# Wichita ASR Project

11-24-2003

Responses to DWR letter of 10-30-03

Figure III-5  
 DRAWDOWN  
 UPPER AND LOWER ZONES  
 SITE TH-04

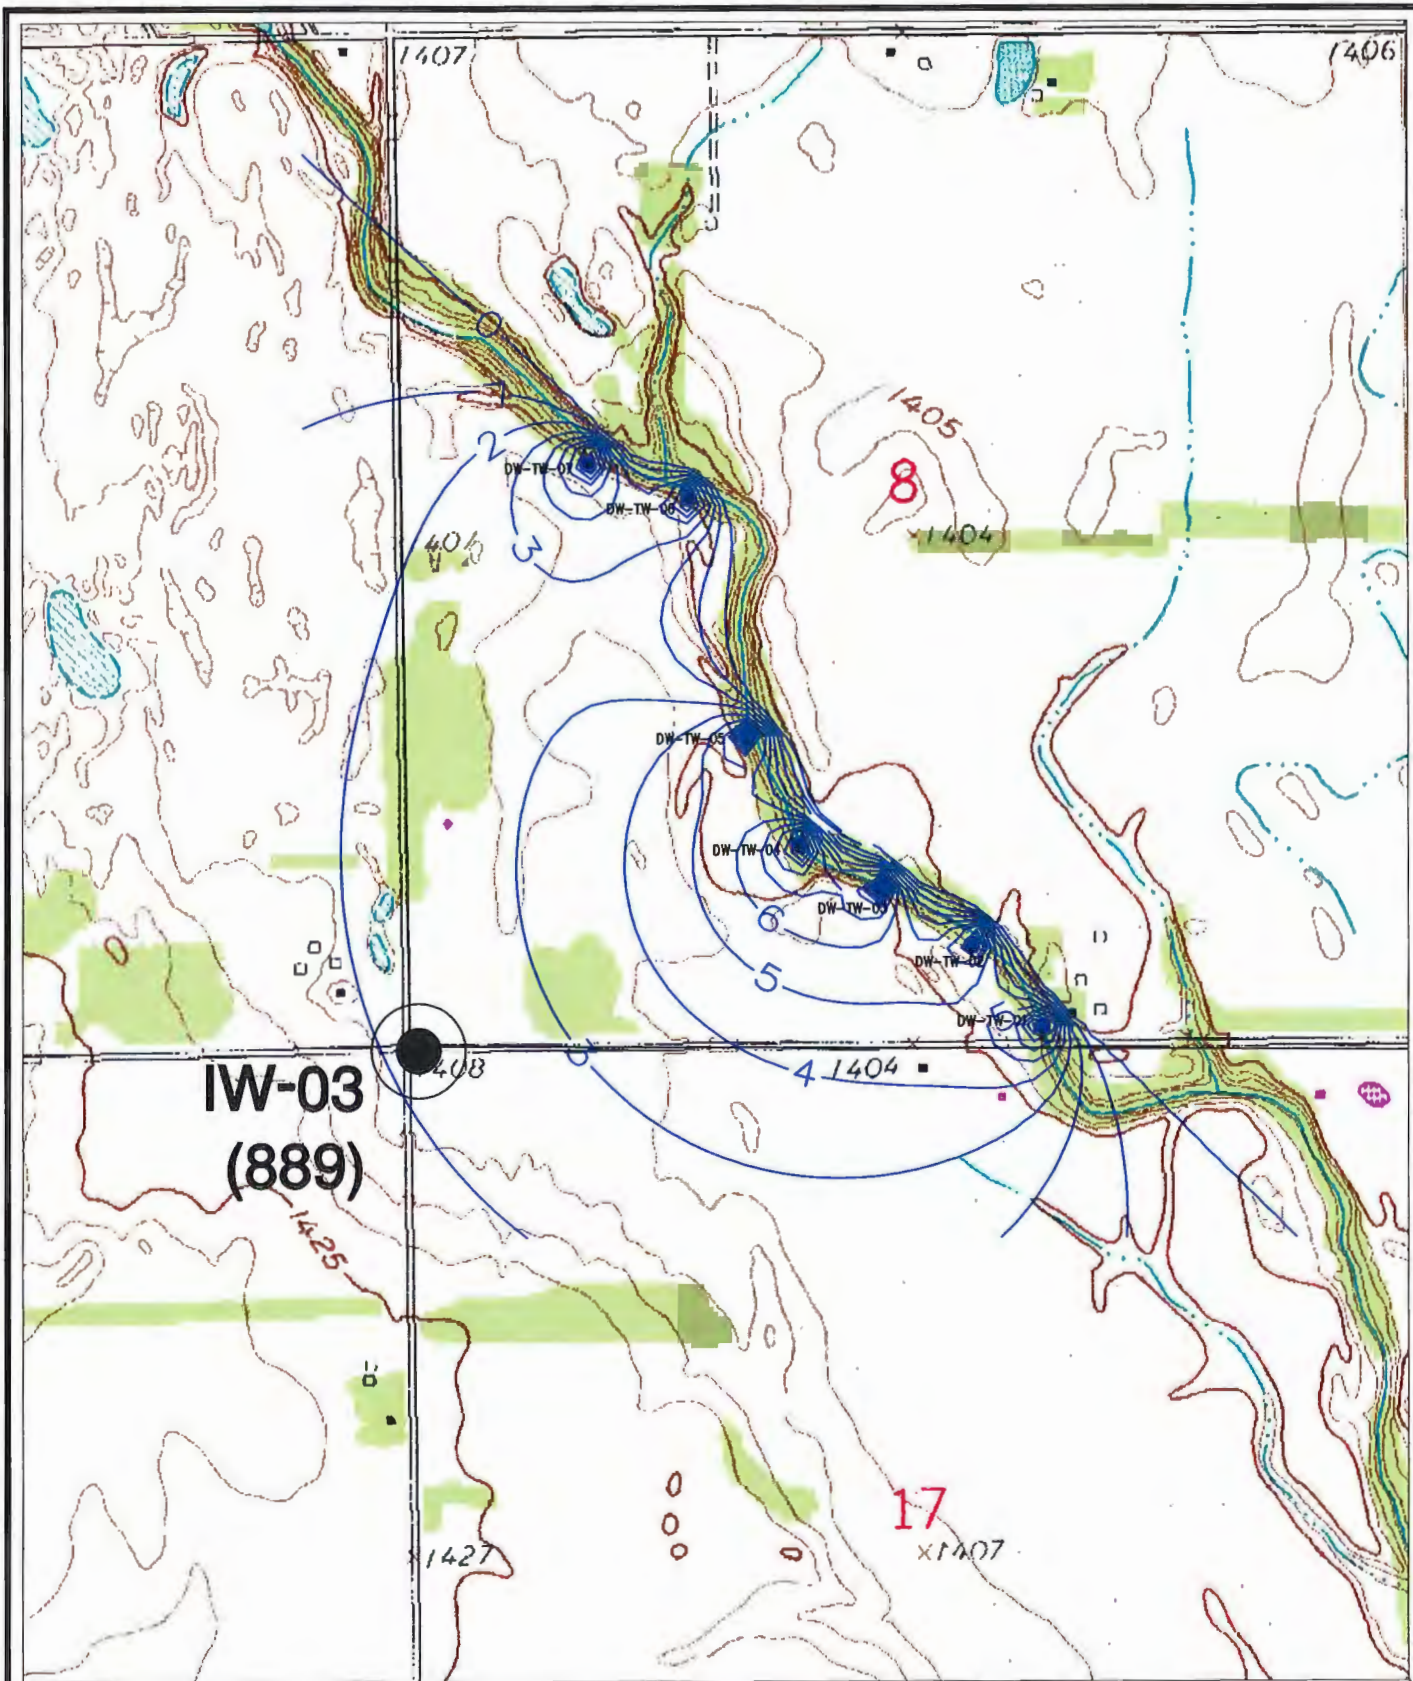
See Fig III-5 (Handed out) Largest OD is <sup>in upper layer</sup>  $\approx 150'$  W of well indicating water moves west before it goes down to get around clay layer.

- Data to show that the proposed bank storage wells, which are proposed to be screened below a clay zone, are able to induce flow from the stream through the clay zone to the well screen, at rates sufficient to support the rate of diversion requested for the bank storage wells. Supporting information should be in the form of computer modeling or engineering calculations. Data on the transmissivity of the confining layer should be provided to show that water may be induced to migrate from bank storage to the lower zone of the aquifer at a sufficient rate to satisfy the rate of diversion requested for the wells.

The clay “zones” shown in the boring logs are not continuous confining layers but are discontinuous lenses. The majority of the water reaching the well flows around these lenses and do not migrate through the clay material. This was demonstrated at the test well near Halstead and reported in the 1996 report. Drawdown in the upper sand layer was greatest at the western edge of the clay lens (100 to 200 feet west of the pumping well). See the attached figures from the report. Modeling was also presented in the report to demonstrating the hydrogeologic setting. **See pages \_\_\_ of the report.**

DIVERSION WELL LOCATIONS

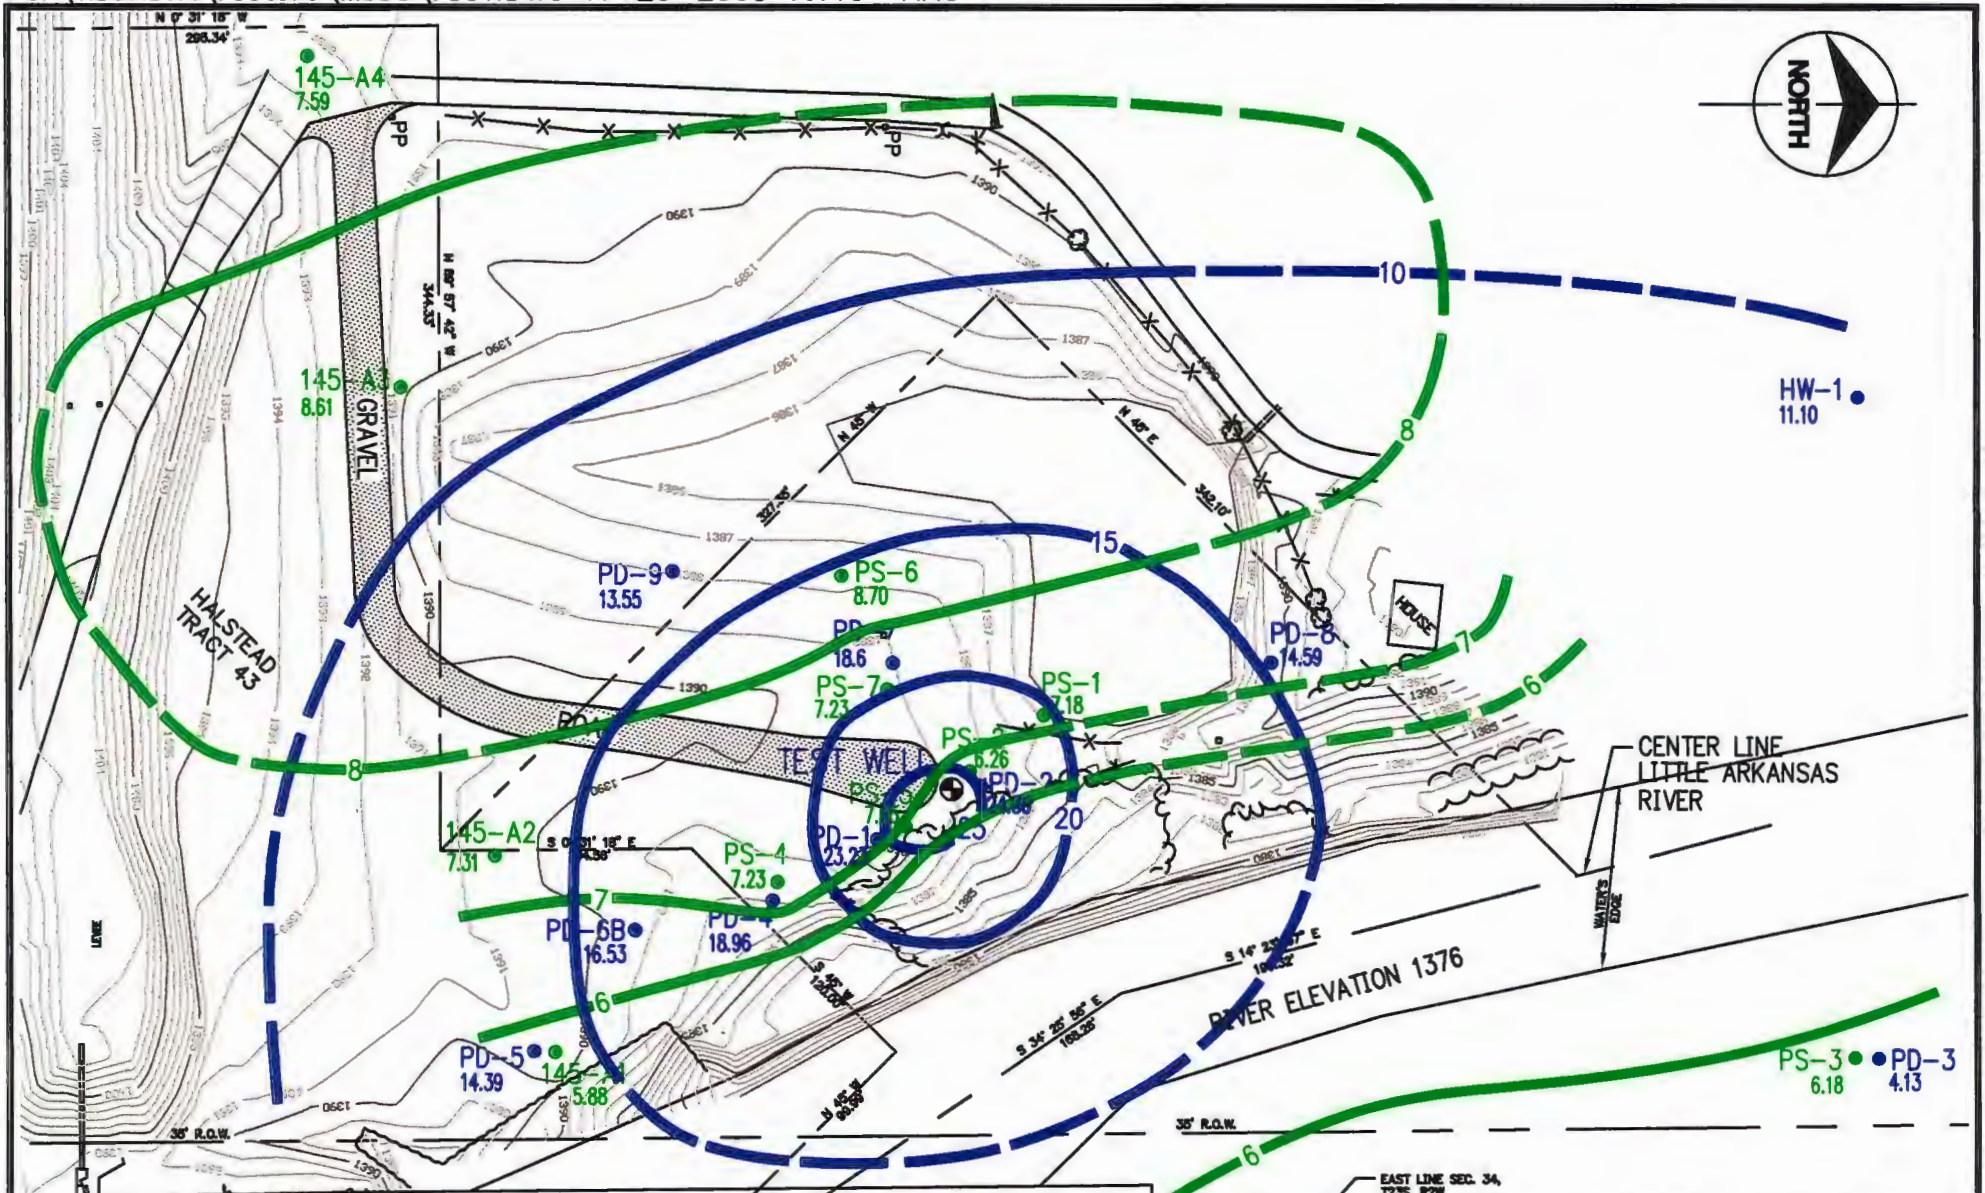
See also (handout) "Diversion Well Locations"  
(Their analysis).

- A map or other data must be provided showing the areal extent of the difference in head required to be developed by pumping the bank storage well in order to induce flow through the confining layer to the well screen. Include information on whether or not the drawdown caused by pumping the bank storage wells extends far enough into the aquifer to affect existing wells.

As discussed above, water moves around the clay lenses and is not moving through the clay lenses. The attached geologic cross section for the Phase I wells shows the same highly variable configuration of clay lenses as found at the Halstead test site.

The pumping test prior to the demonstration project included monitoring water levels from a number of wells that were installed perpendicular to the river. The most inland well, A5, was approximately 1,500 feet from the test well. During the initial 24-hour acceptance test at a pumping rate of 923 gpm, there was no discernable drawdown at that well. For the 30-day test, with base flow conditions, the well saw about 1-foot of drawdown.

During the extended 75-day test with pumping rate of 978 gpm, a high flow event occurred during the initial part of the test. During this approximately 30 day time period, there was no observed drawdown in the A5 well. After the river returned to base flow, drawdown of about 1 to 1½ feet developed. These observations reinforce that if the diversion wells are pumped only during above base-flow events that they will induce river water into the aquifer at a rate that replace the water pumped from the wells, and that there will be no impact on pre-existing groundwater levels near the wells.

The two closest permitted wells to the proposed diversion wells are about 3,500 and 5,000 feet away. Based on the observations described above, no impacts are expected to these wells, even if the diversion wells are pumped during base flow conditions. However, these applications require that these wells only be pumped during above base flow conditions, which makes an even greater margin of safety that nearby wells will be impacted.

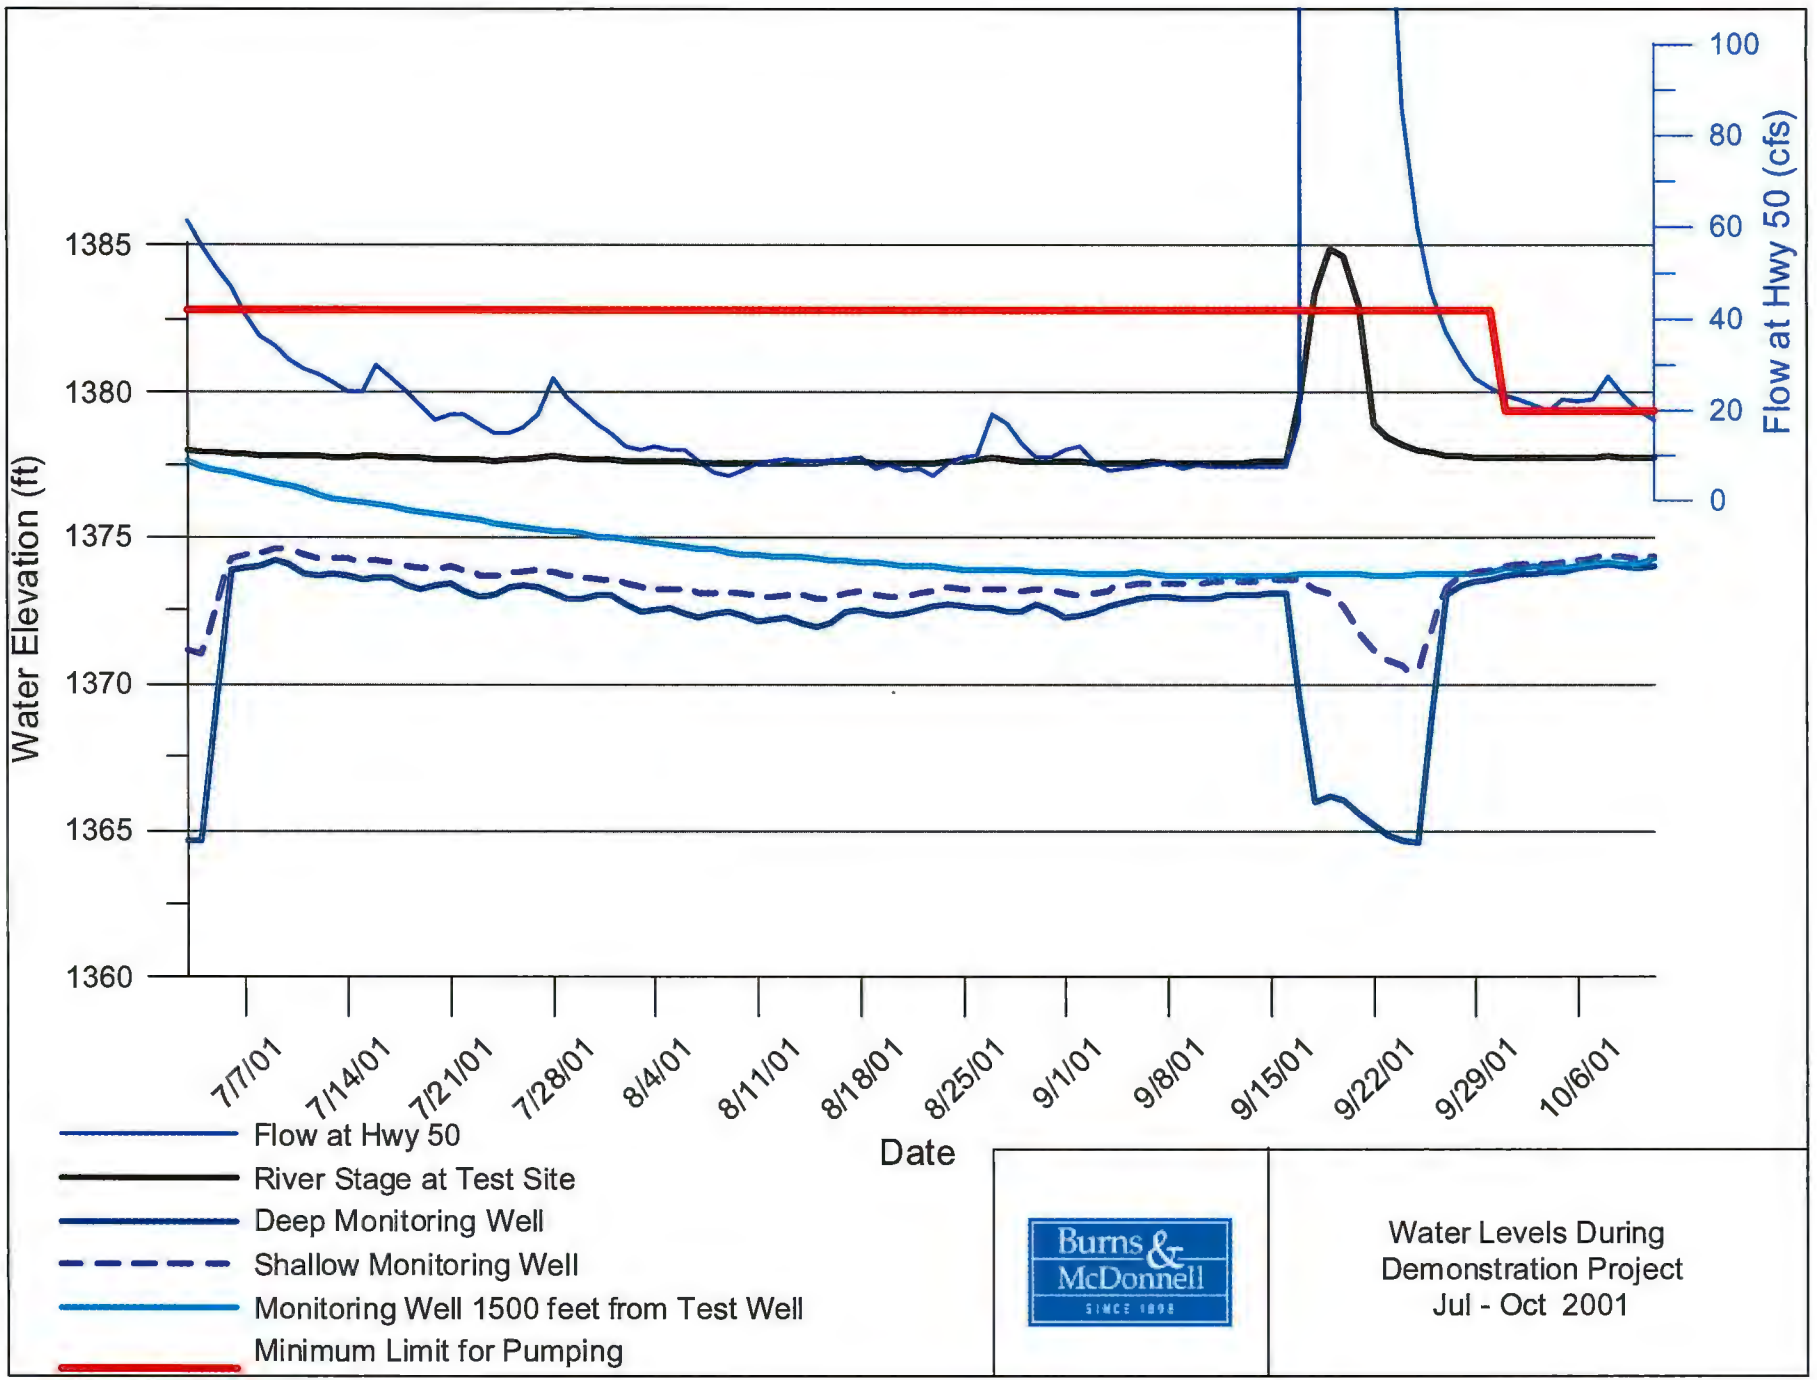
- Provide calculations determining the point in time when equilibrium conditions are reached, wherein the water induced from the river equals the pumping rate of the bank storage well. What is the time lag from commencement of pumping to the time this equilibrium is reached?

The second example from the USGS data is from July to October 2001.

- 1) The graph shows termination of pumping near the early part of July.
- 2) Groundwater levels drop in response to lower river levels and assumed dry weather with up gradient irrigation pumping.

- 3) Pumping begins with a high flow event in mid September. During pumping, groundwater levels change (shallow and deep wells near the river) with changes in river flow demonstrating near equilibrium conditions.
  - 4) There is no apparent change in water levels in the monitoring well about 1,500 feet away.
  - 5) Recovery to pre pumping groundwater levels was rapid (less than 2 to 3 days) after pumping stopped.
- Until equilibrium is reached, what is the extent of the cone of depression out into the aquifer, and what is its effect on surrounding wells?

As discussed above, the cone of depression extended to about 1,500 during pumping at base flow conditions and did not show impacts during pumping for the demonstration project. That would be a “worse case” condition. As shown in the hydrographs, there would be other occasions there might actually be **no cone of depression**, and even with the well in operation ground water levels would be higher than during base flow conditions. No impact is expected on the two wells 3,500 and 5,000 feet away from the Phase 1 wells when pumping during above base flow conditions.
